CITY/BOROUGH OF JUNEAU
155 South Seward Street, Juneau, Alaska 99801

FILE NO.: VAR2012 0029

PROPOSAL: A variance request to the requirement that lots be designed to conform to a minimum rectangle of 100' by 100' in a D-3 zone district - CBJ 49.15.460.(4)(A)(i)(b).

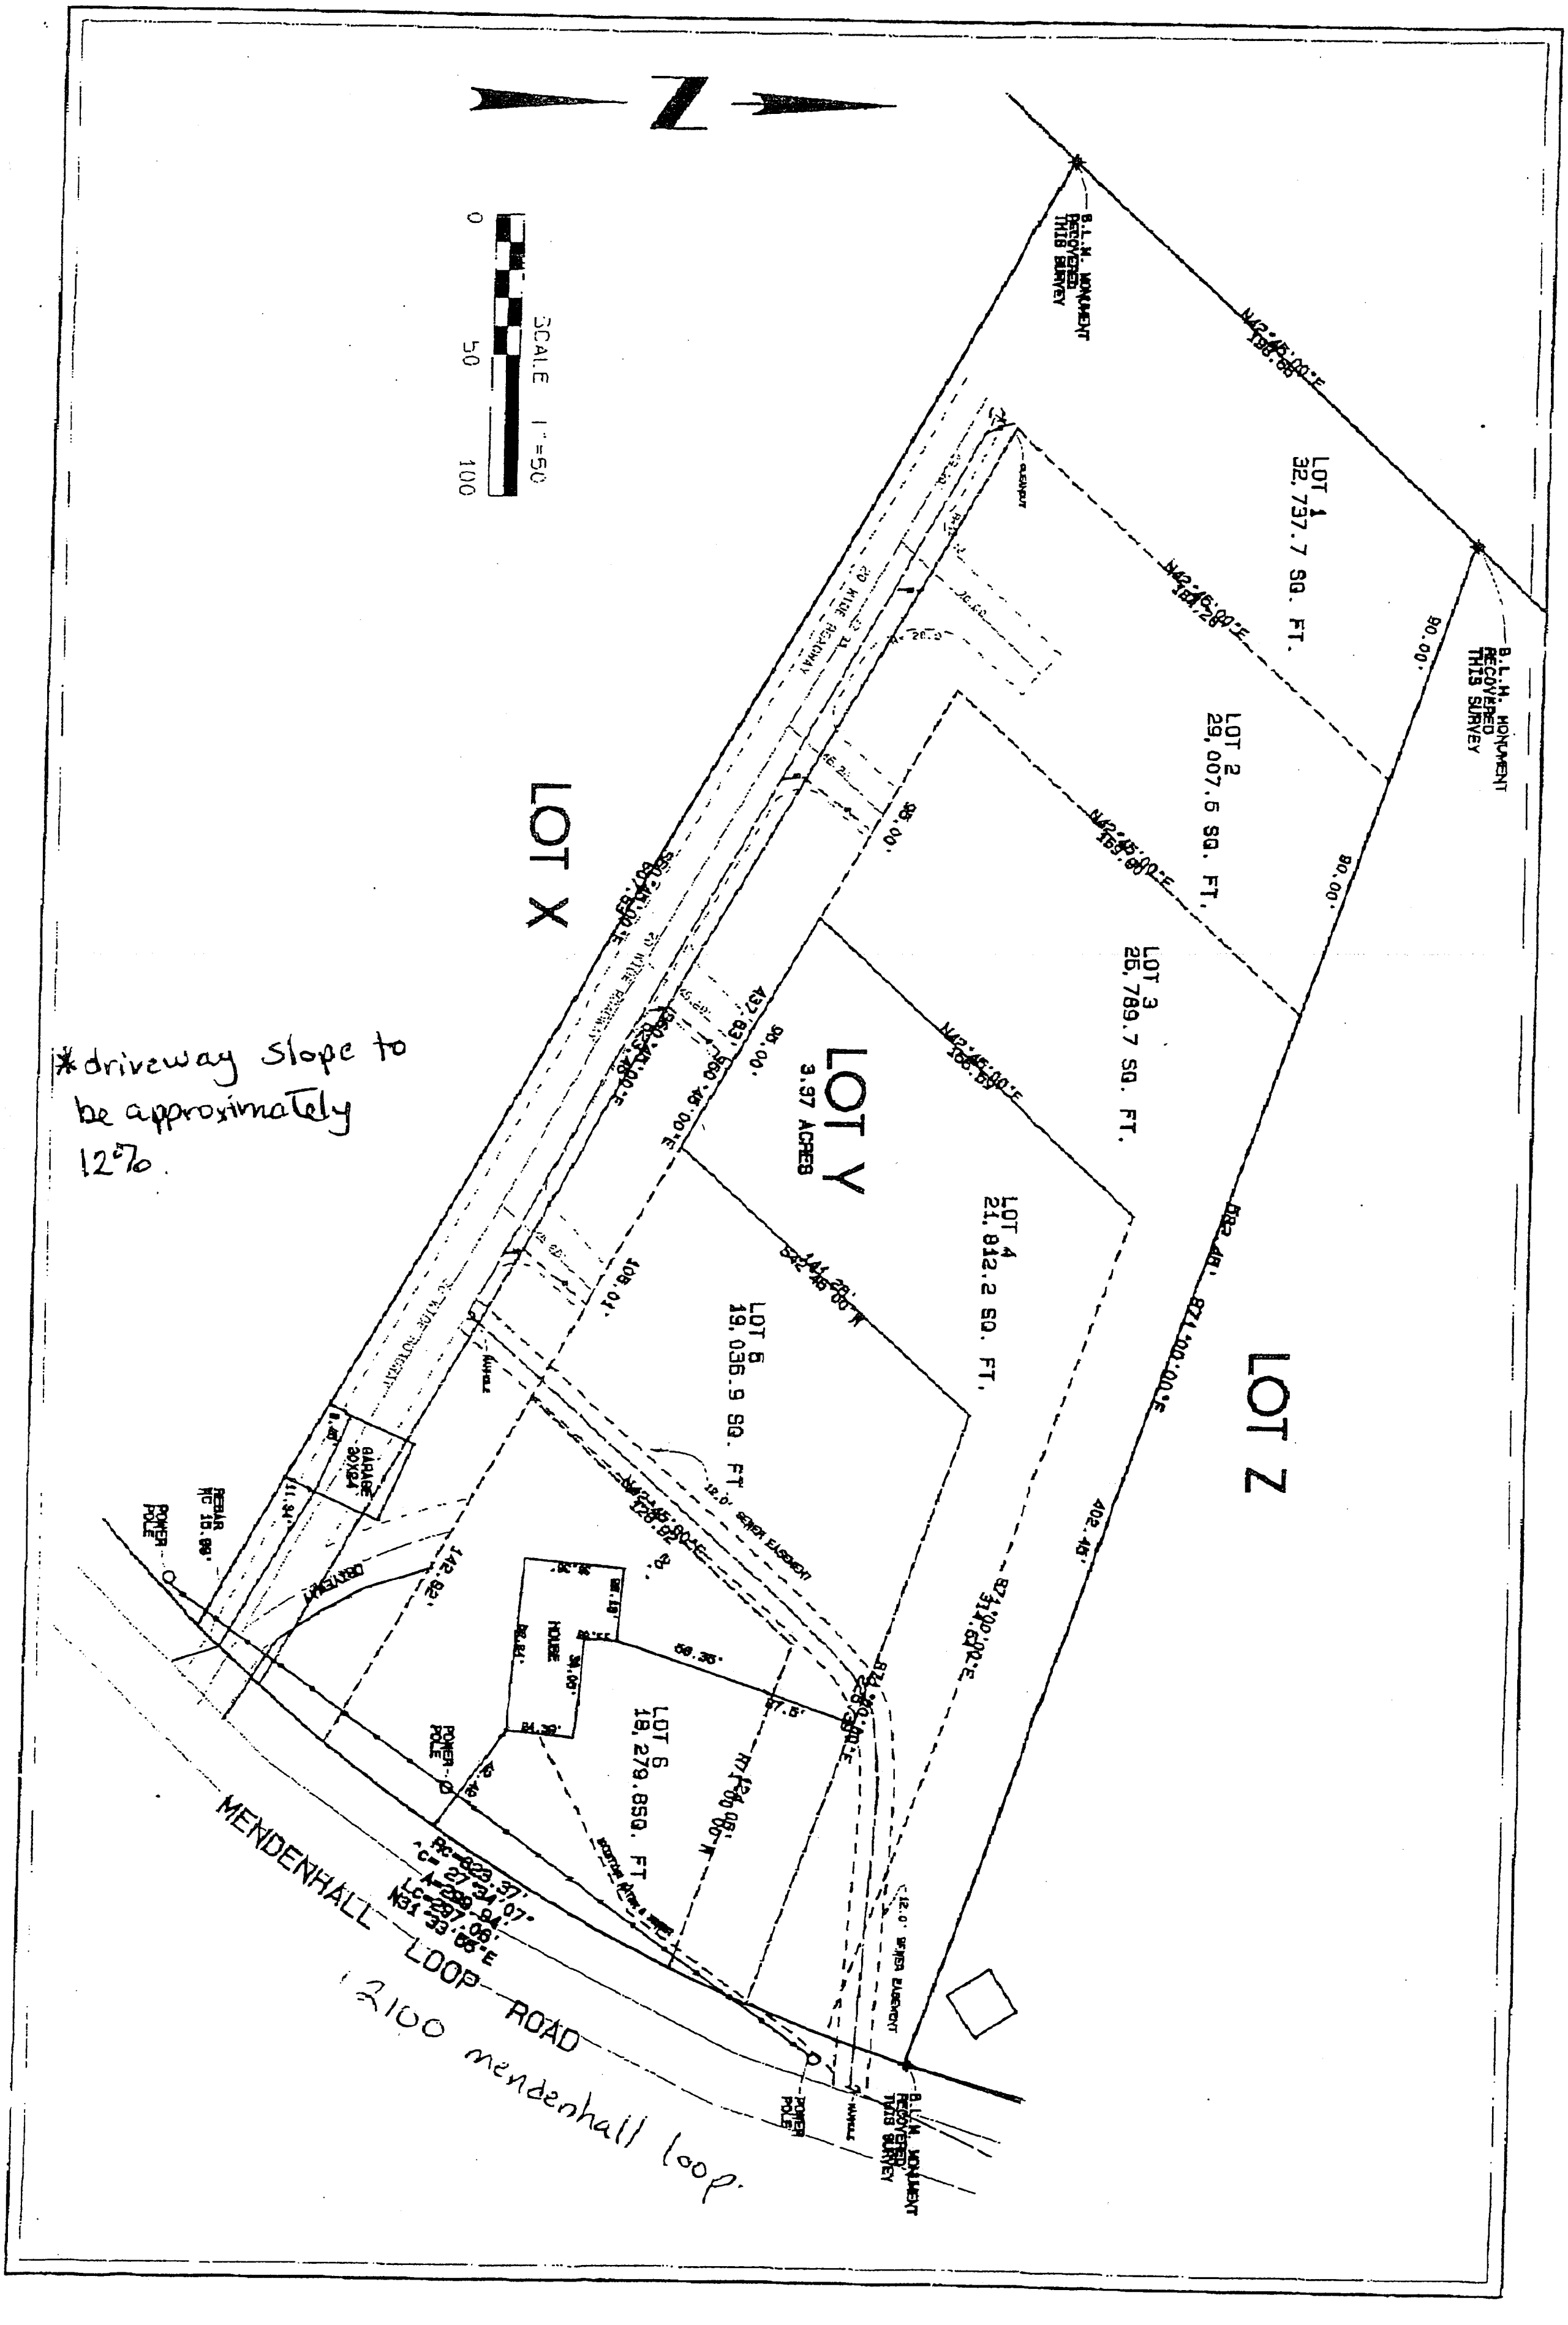
The proposed subdivision meets the requirements outlined above with the exception of (b) as four of the proposed six lots are less than 100' wide as required in the D-3 zone. The four lots in question are proposed at 90 feet by 190 feet, 90 feet by 185 feet, 95 feet by 169 feet, and 95 feet by 155 feet. All lots exceed the required lot area as well as the lot depth standards for the D-3 zone district. Due to the shape of the lot being long and narrow, this configuration for subdivision is requested by the applicant to yield six lots. A shared driveway is proposed for access to the six lots (see the Site Plan in Attachment A).

The requested variance would provide substantial relief to the property owners in that the lot could be subdivided into six lots. The variance would allow these lots to be created, through the subdivision process, to the D-3 district standards. Four of the proposed lots do not meet the D-3 zone lot width requirement of a minimum of 100 feet, but do exceed the lot depth and area requirements. Additionally, the subdivision has been designed so that each lot has a minimum of 30 feet of frontage on Mendenhall Loop Road, a maintained right-of-way. However, one driveway is proposed for these six lots as access to the road; individual vehicular access from each lot would not be available. The Department of Transportation (DOT) supports this design utilizing one access driveway for the six lots and has requested a plat note indicating that access is not allowed from individual lots to Mendenhall Loop Road.

If this variance is approved, staff recommends a condition that a plat note be included that limits vehicular access from individual lots to Mendenhall Loop Road, and that access be limited to the single, shared driveway only. This requirement would improve neighborhood safety by limiting multiple access points onto the roadway, thereby making the variance application consistent with justice to other property owners.

DOT, which maintains Mendenhall Loop Road, supports the single access point for the lots and proposes a plat note that limits access from the lots. If this variance is approved, staff also proposes a condition requiring a homeowner's association to ensure continued maintenance of the driveway to ensure safe and practical access to the properties. The Fire Department also proposes a condition requiring adequate fire apparatus turn-around for the driveway. With these recommended conditions, public safety and welfare can be assured.

The subject parcel is a long, somewhat narrow parcel along Mendenhall Loop Road. It's wider along Mendenhall Loop Road at approximately 300 feet along a curve, and then tapers back to approximately 198 feet wide on the northwest side/rear of the property. The longest side is approximately 607 feet. Due to the smaller width of the property, in order to dedicate 60 feet of platted right-of-way for a road that would provide access to the lots would take up a significant amount of area and less area would be available for lots onsite. The proposed configuration provides a driveway easement for all six lots with access to Mendenhall Loop Road. However, a variance to this standard would not be needed if the subdivision were redesigned to propose only five lots; in that scenario, all lots would be able to meet the 100' by 100' rectangle requirement. However, even with five lots, this subdivision would still be a major subdivision which would require major subdivision review and approval by the Planning Commission. Development and construction costs would be more reasonable if they were spread out over six lots rather than five lots; however, the applicant does not offer any specific reason stating that compliance with the existing standards make the project unreasonably expensive.

Thank you for the opportunity to comment. DOT considers the existing driveway the preferred access to Glacier Highway to these lots . We would request a plat note stating that no future access from lots 2,3,4,5 & 6 Backloop Road be allowed.

1. The subdivision plat shall include a note requiring that all lots be accessed with a single, shared driveway only and that vehicular access to Mendenhall Loop Road from the individual lots will not be allowed.

4. Fire apparatus access and turn-around must be provided and shall be constructed to International Fire Code Standards prior to issuance of any Temporary Certificate of Occupancy (TCO) or Certificate of Occupancy (CO) for dwellings on the property.
